June 2020 Planning Commission

Engineering Comments Summary

**SPRINGDALE PLANNING COMMISSION
COUNCIL CHAMBERS
201 SPRING
5:00 P.M. JUNE 2, 2020
Tentative Agenda**

To: Planning Commission
From: Staff
Date: June 2, 2020
RE: L20-11 Large Scale Development Williams Tractor

DRAWN BY: JEI
 CHECKED BY: JEI
 DATE: 2/27/2020
 JOB NUMBER: 19-1045
 SHEET NAME: DEMOLITION & STORMWATER POLLUTION PREVENTION PLAN
 File No.: 19-1045.dwg
 C3.0

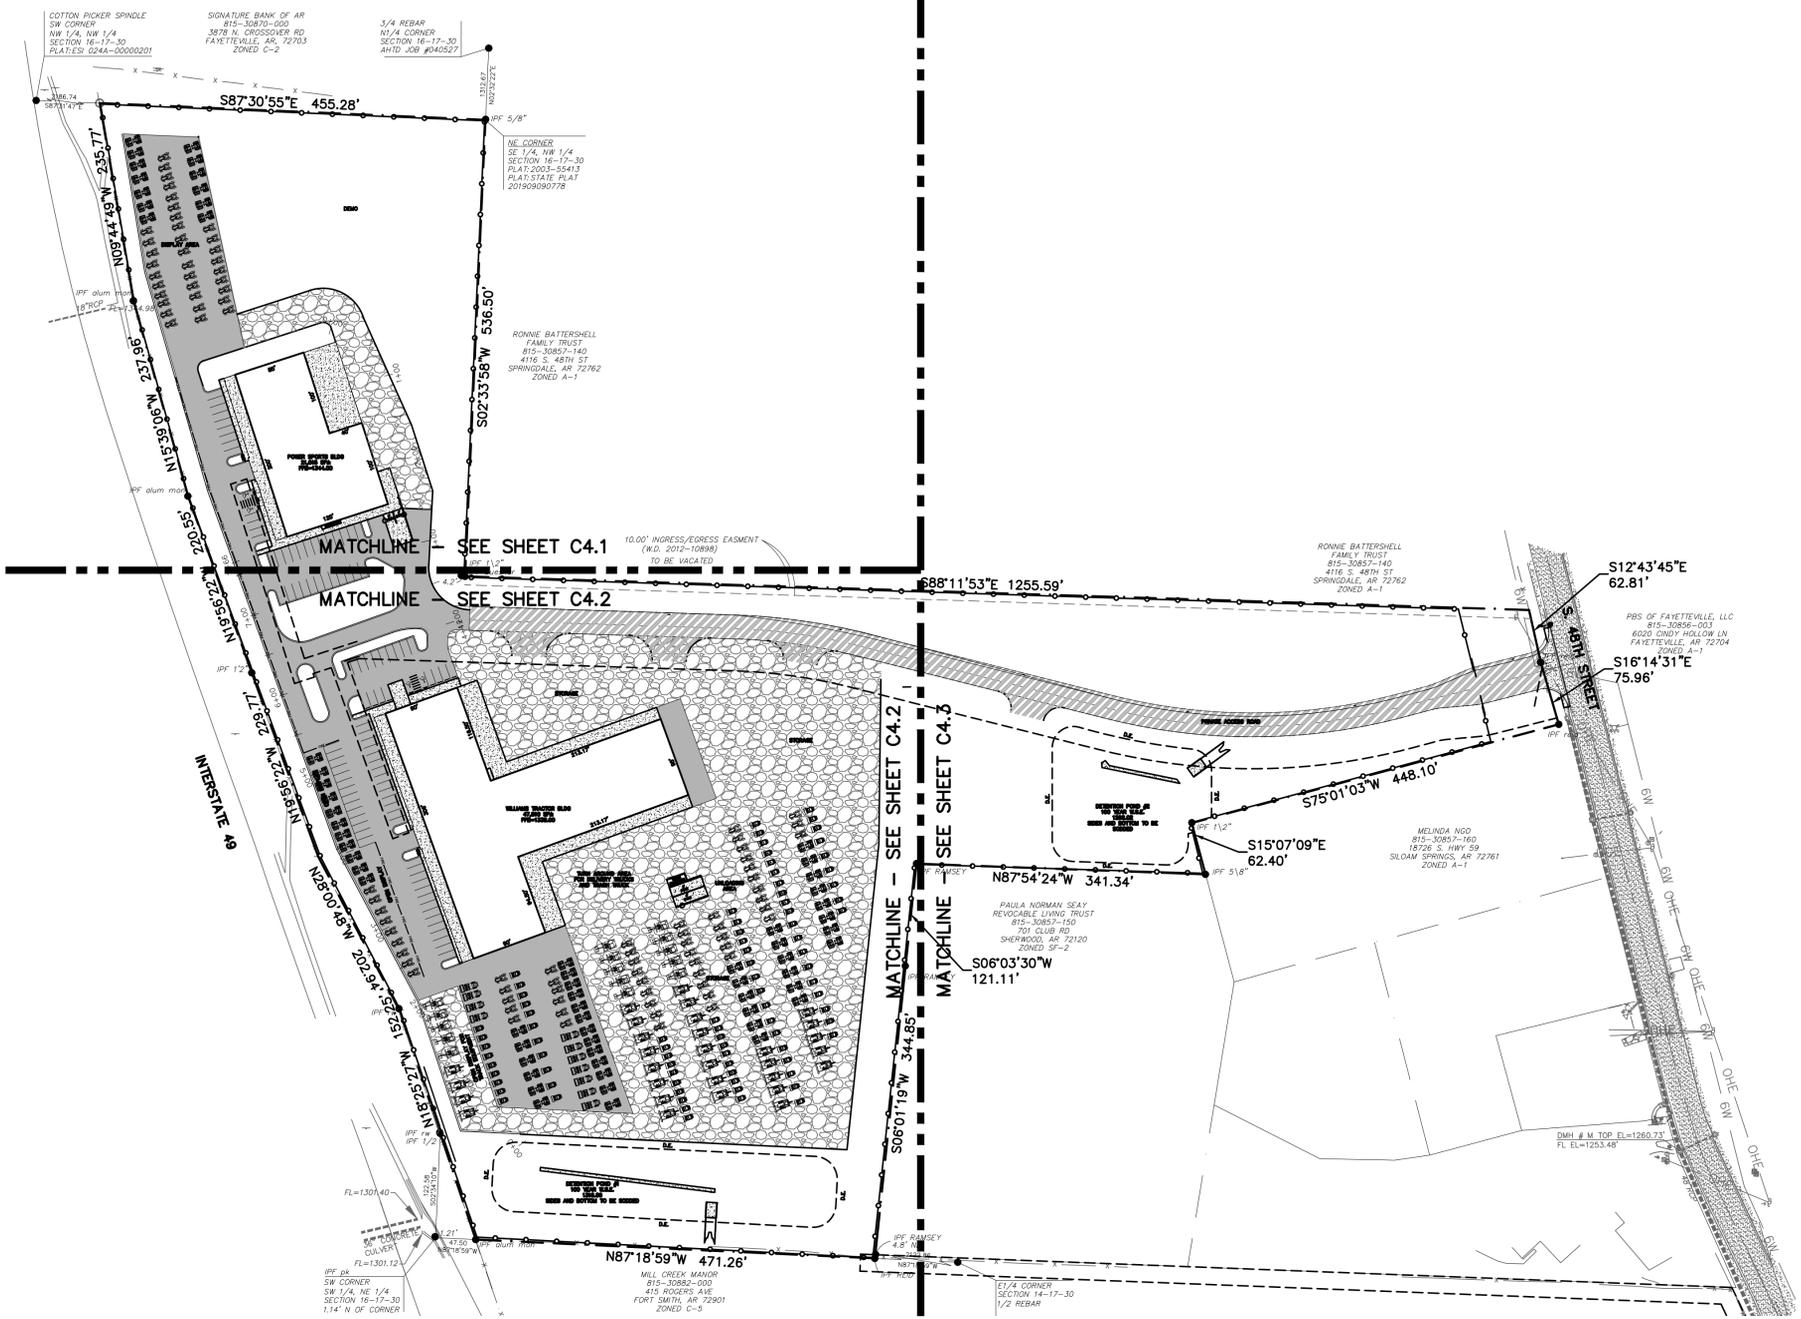
- Show concrete pipe in outlet detail and revise drainage report where it mentions HDPE
- Photometric plan is not legible

- **107.1** - Show & Label all temporary construction stockpiles, parking, entrances, egress, roads, or access as "**Temporary**" on the Grading or Erosion Control Plan.

SITE PLAN 2
 File No. 19-1045.dwg
 C4.2

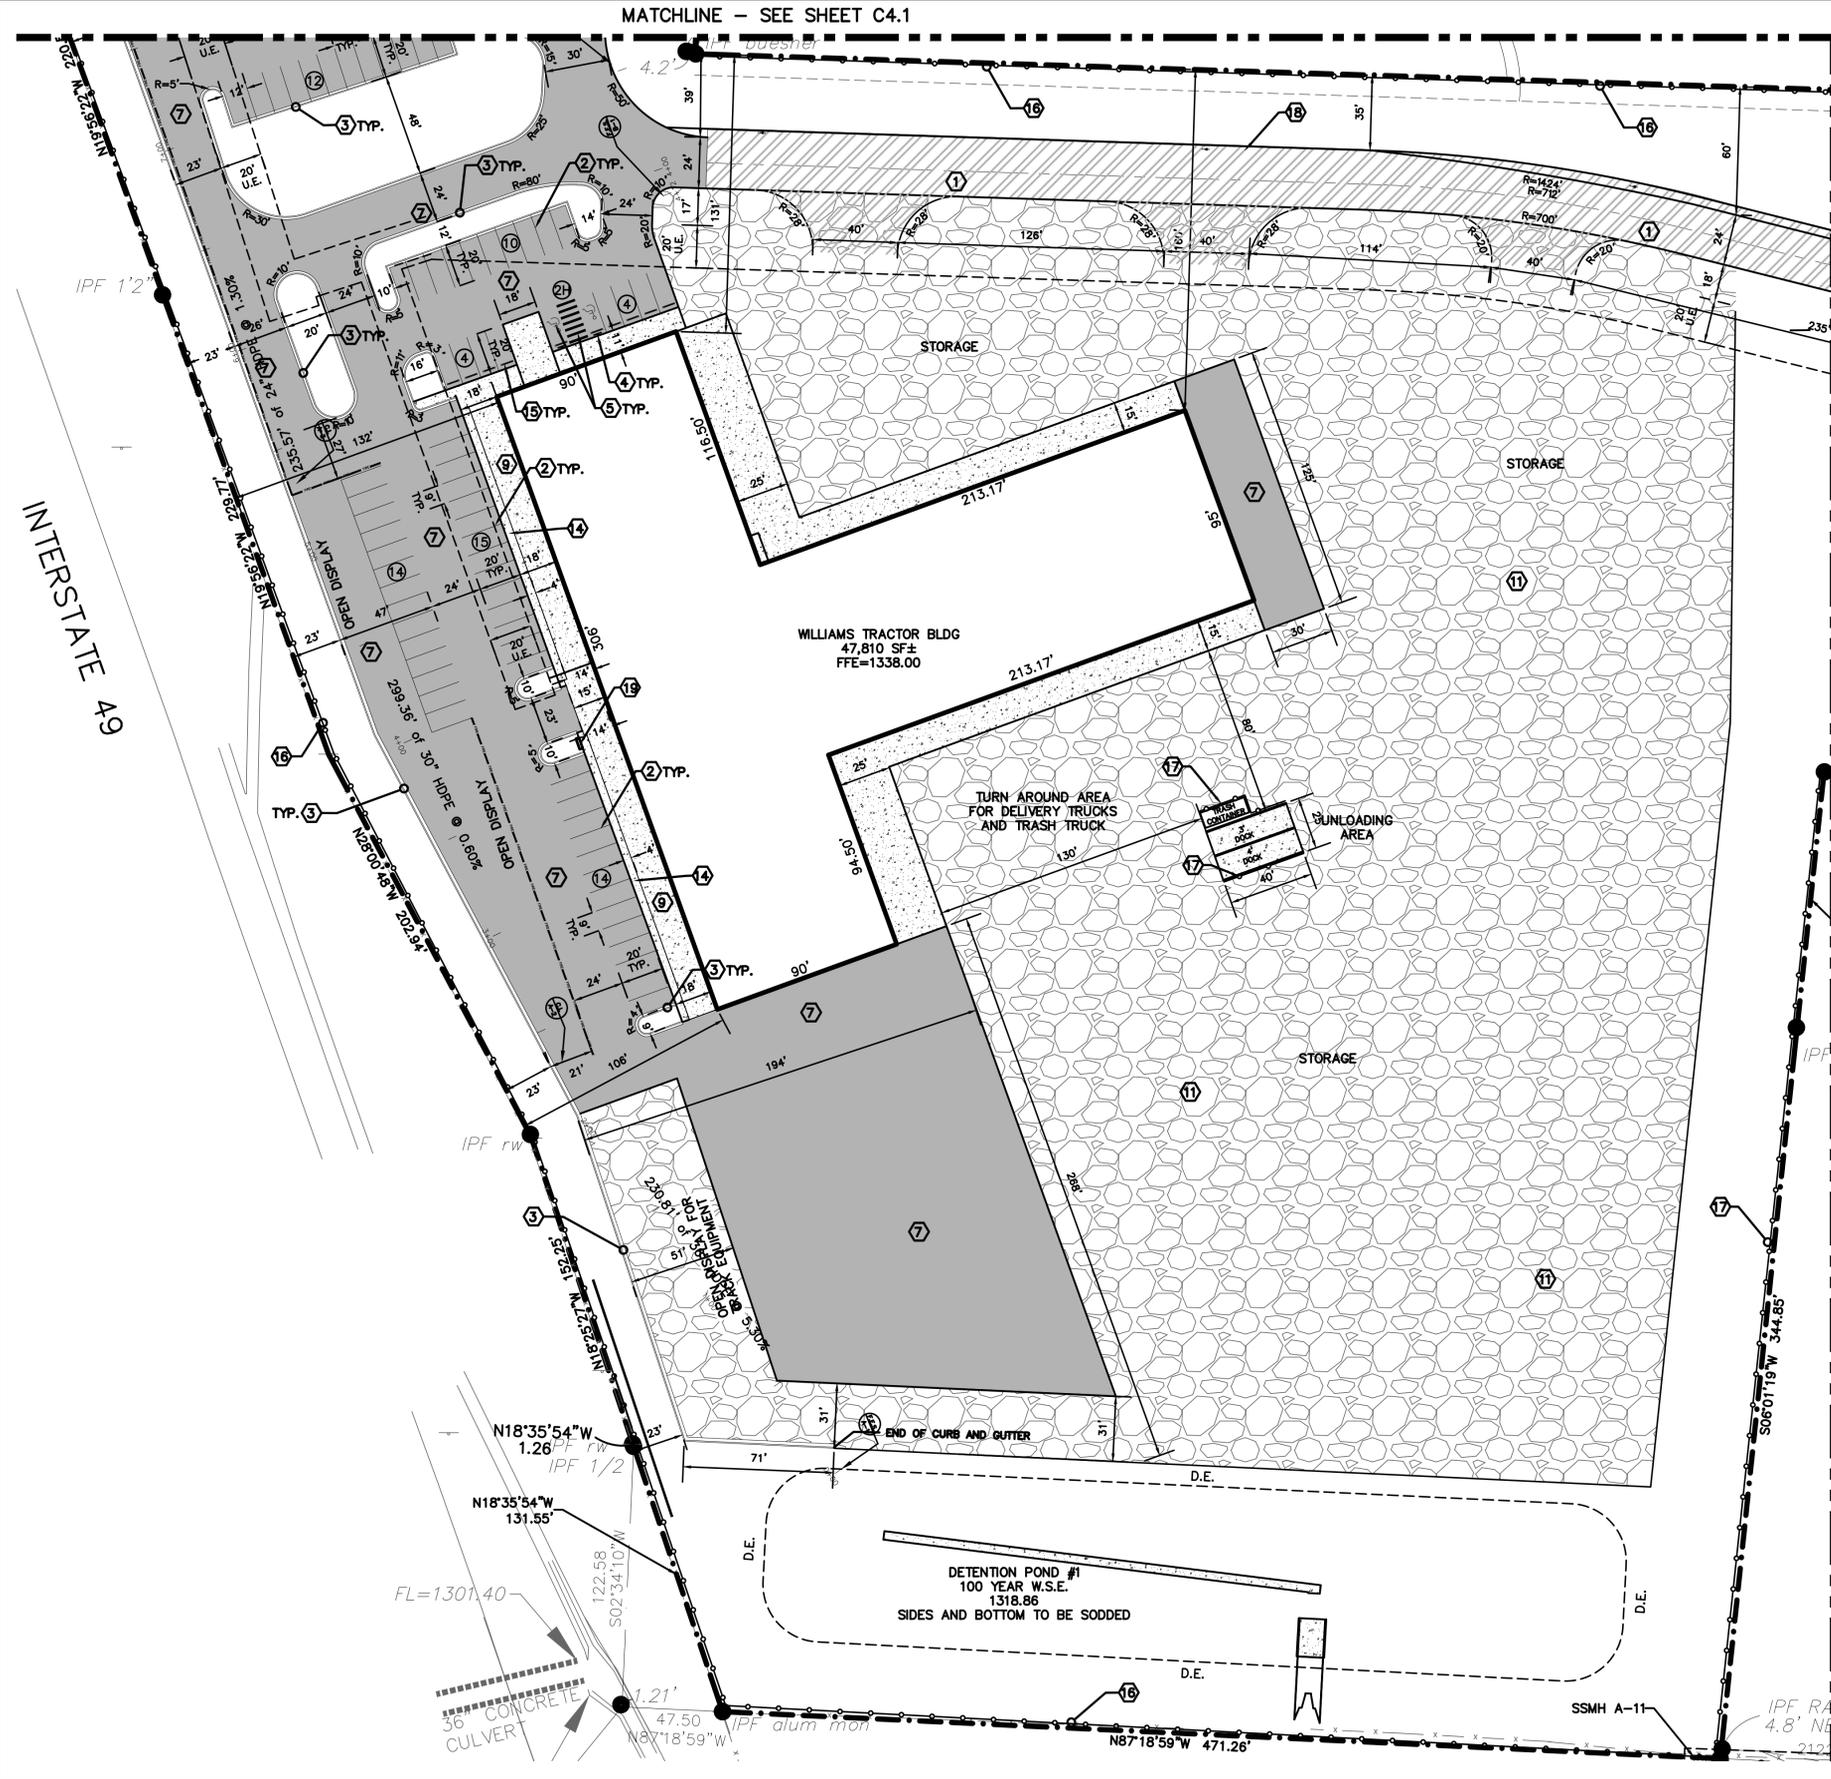
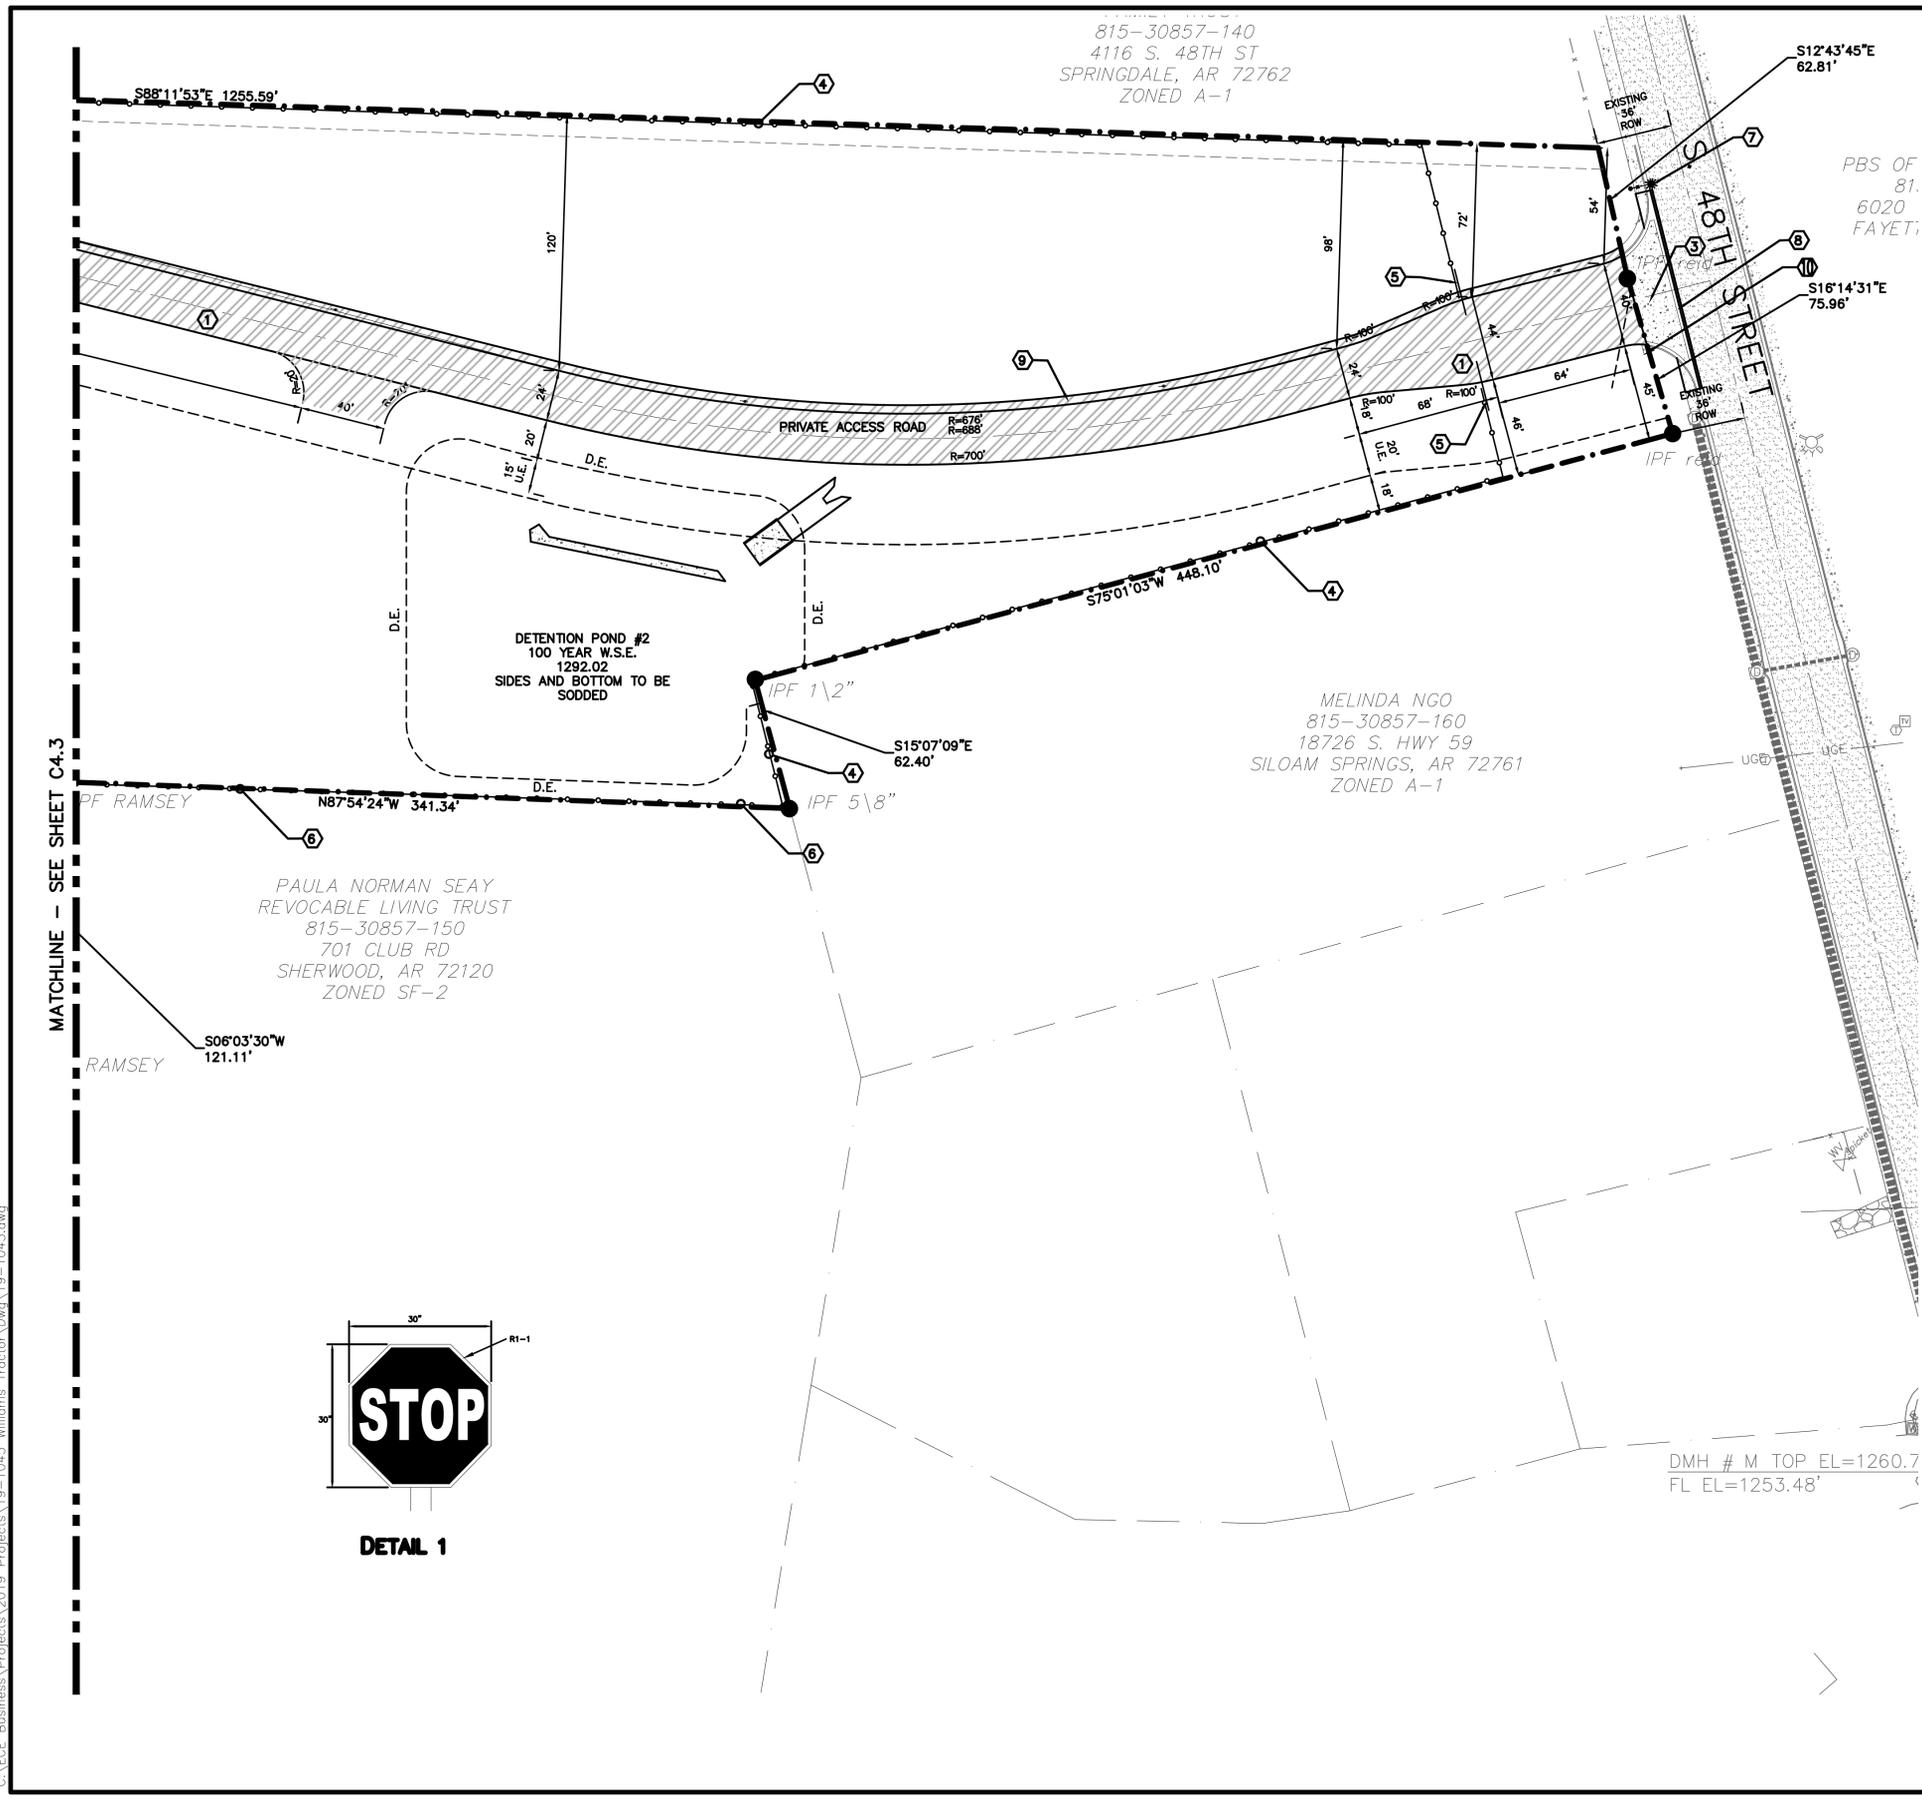
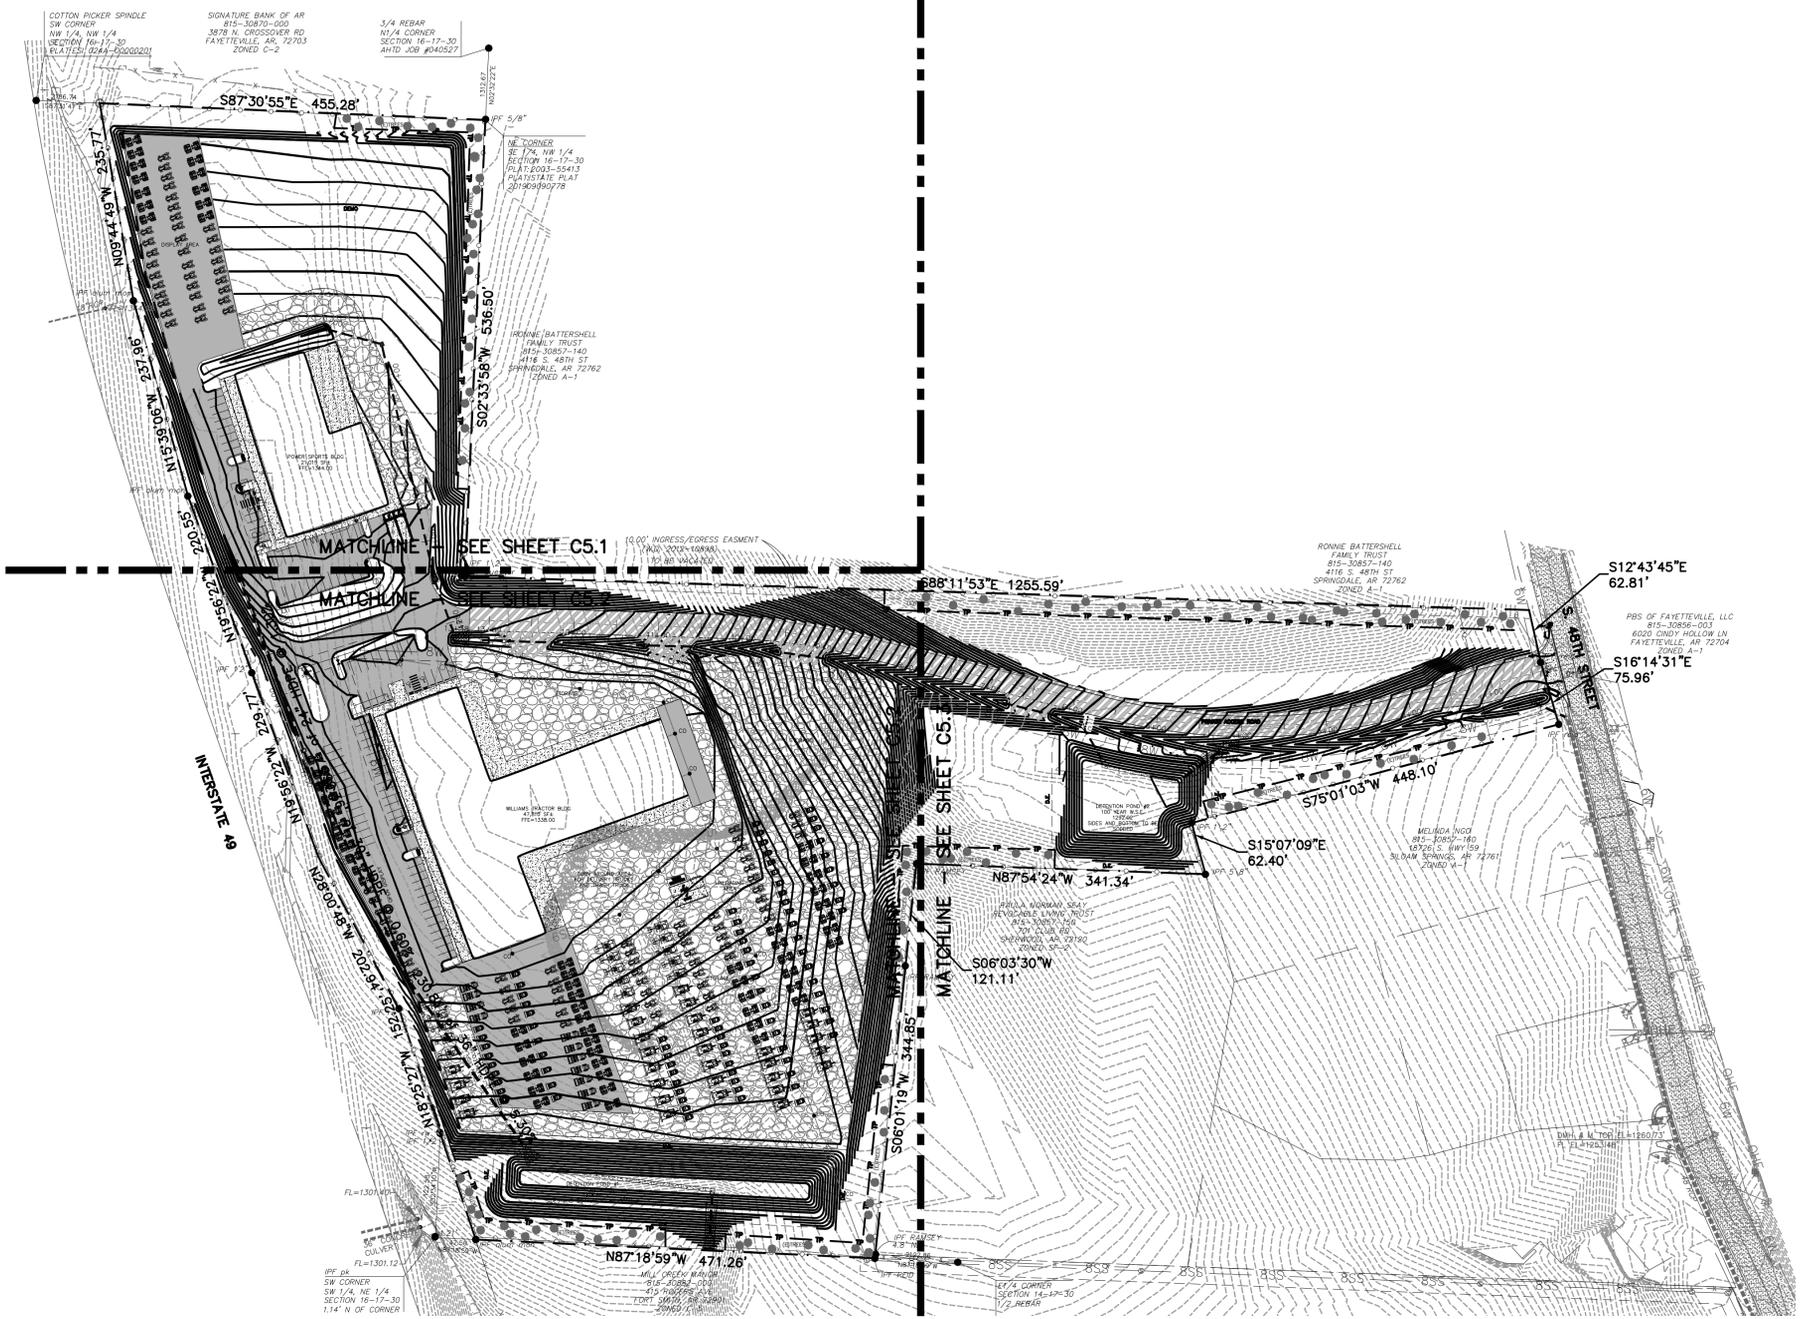
- **Spot elevations needed I parking area.**
 - **Any fire lane/no parking?**
 - **Label the R.O.W.**
 - **Show the ditch section along road.**
